**PRM-50-95
(75FR66007)**

Subject: Response to the U.S. Nuclear Regulatory Commission's ("NRC") notice of solicitation of public comments on PRM-50-93 and PRM-50-95; NRC-2009-0554

COMMENTS ON PRM-50-93 AND PRM-50-95; NRC-2009-0554

II. Response to NEI's Comments on PRM-50-93 and PRM-50-95, Dated November 24, 2010

Fig. 16: CORA-16; Temperatures of unheated rods

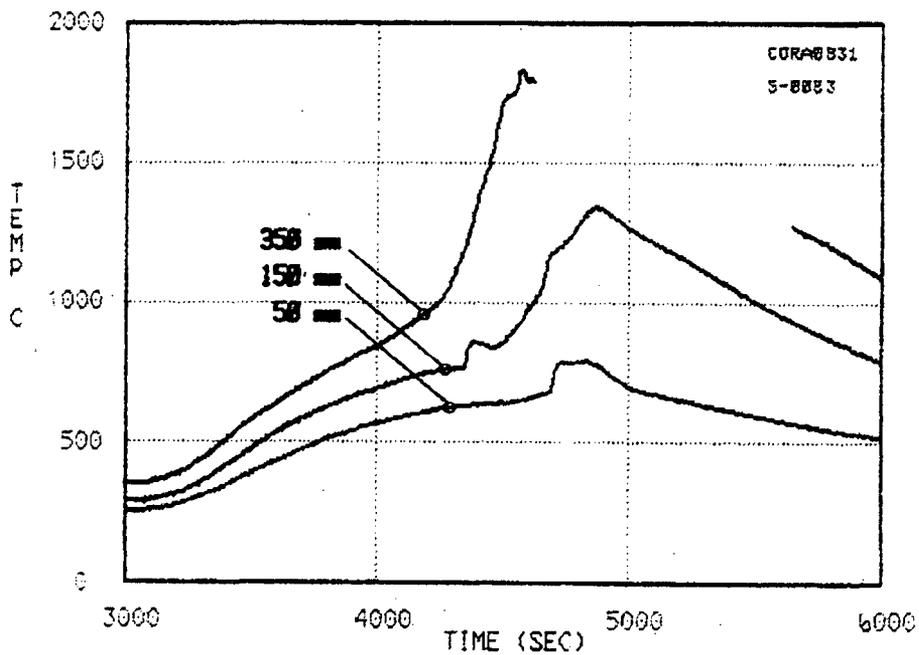
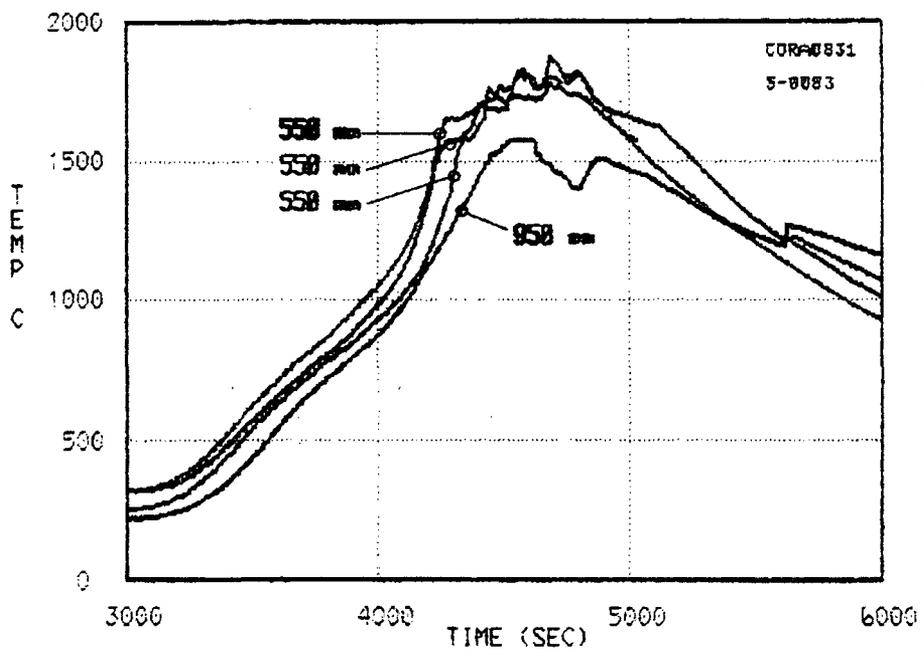
First, NEI is correct that the temperature of the BWR cruciform control blades would be significantly below that of peak fuel cladding temperatures, in the event of a LOCA, as demonstrated by the CORA-16 experiment. However, if the fuel cladding were to incur runaway oxidation between 1832°F and 2192°F, peak cladding

¹¹¹ See Appendix A Figure 16. CORA-16; Temperatures of Unheated Rods and Figure 17. CORA-16; Temperatures of the Absorber Blade.
